kris pastoriza response to: Response to inquiry

Codispoti, Jennifer A May 25, 2023, 6:21 PM (9 hours ago)

1. Requesting a map with the structures currently on your property and new structure locations as well as the existing and proposed structure heights

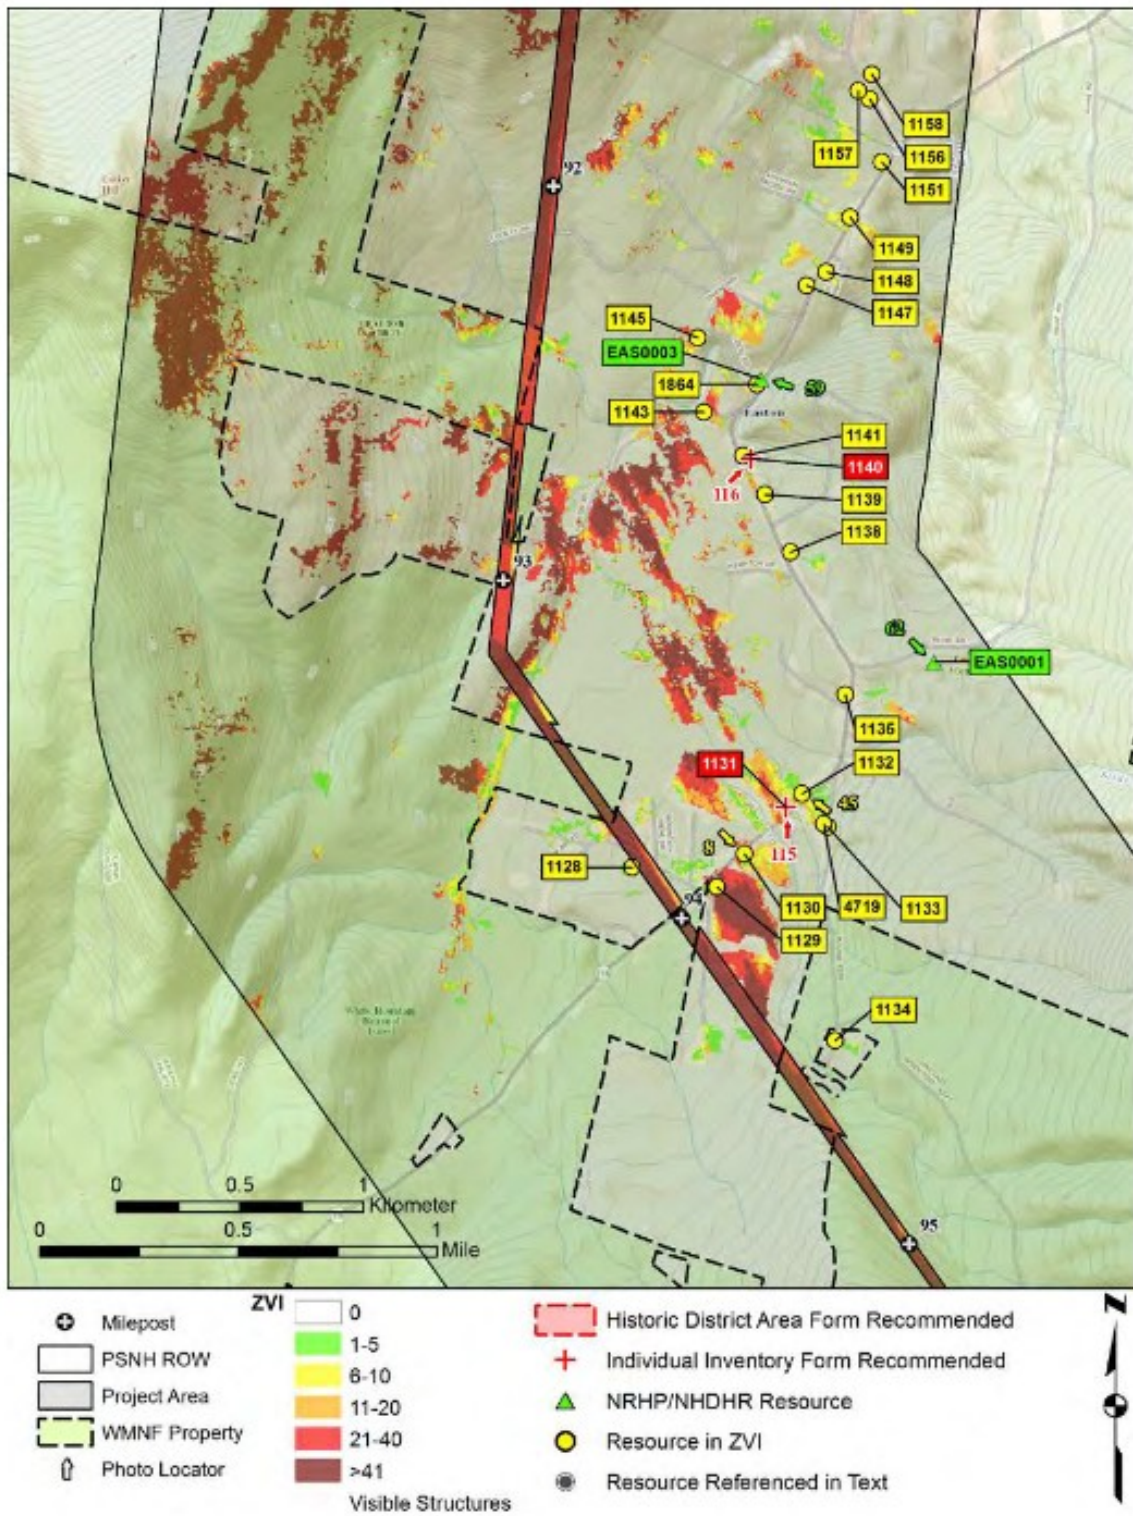
kris response: Would the proposed new transmission line be capable of carrying simultaneous HVAC/HVDC current?

If so, how much would this increase the power carrying capacity of the lines?

Eversource Response: The existing line is High Voltage Alternating Current (HVAC) and will be the same when rebuilt.

Before picture – from Eversource for petition

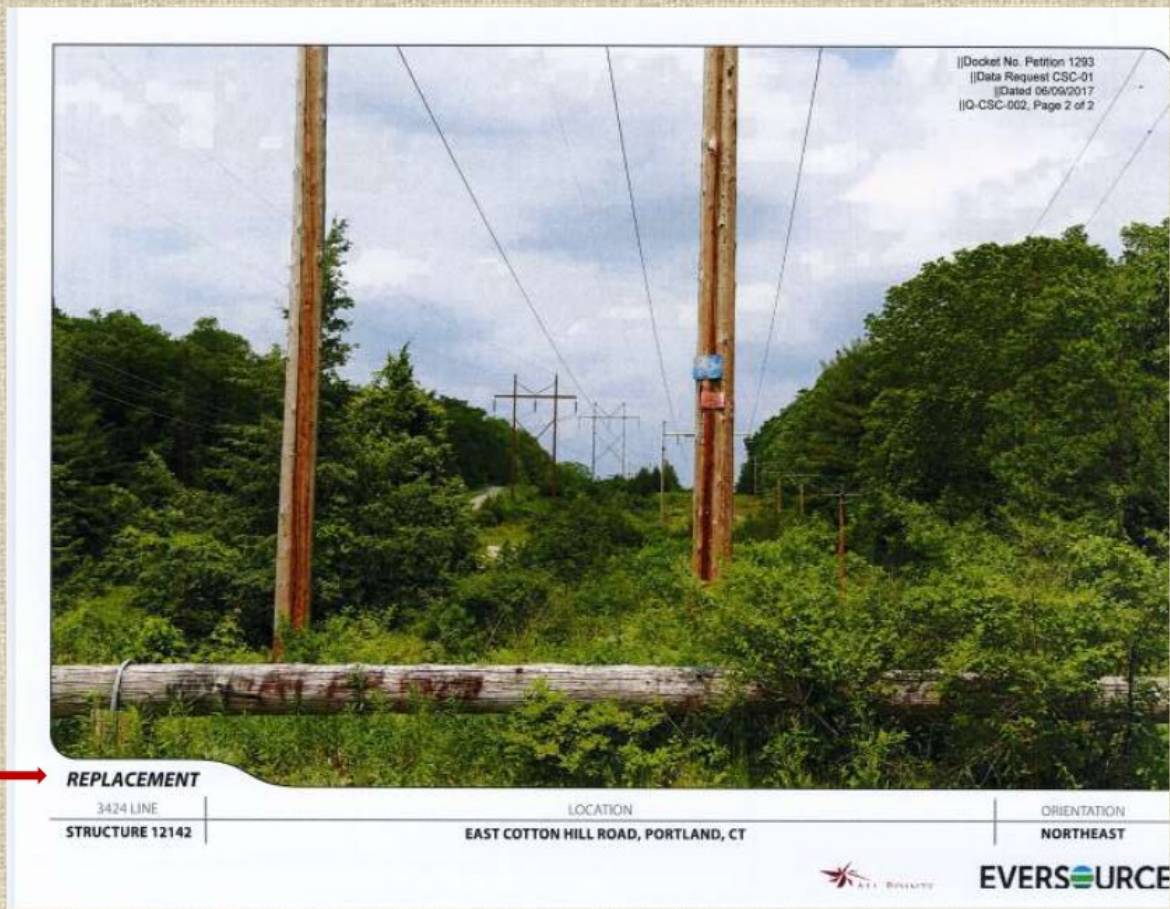
Kris response: I will recommend all ROW encumbered landowners to photograph their ROWs, extensively and with drones, if they can afford this.

Eversource Response: It is general practice for Eversource and/or its contractors document existing conditions prior to construction.

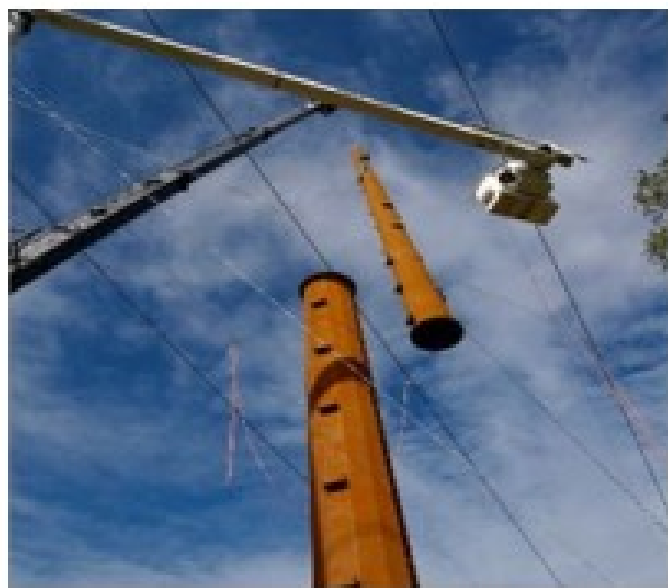
kris response: No road building will be allowed here. Construction plans must be very similar to construction plans for the rest of the 140 miles north-south new 115kV 1272 line.

Eversource Response: Construction plans are not yet developed. Mapping for the project is not yet available, but will be in the coming months. Once the draft mapping is available, we will post it to our website www.eversource.com/X178-Line- .
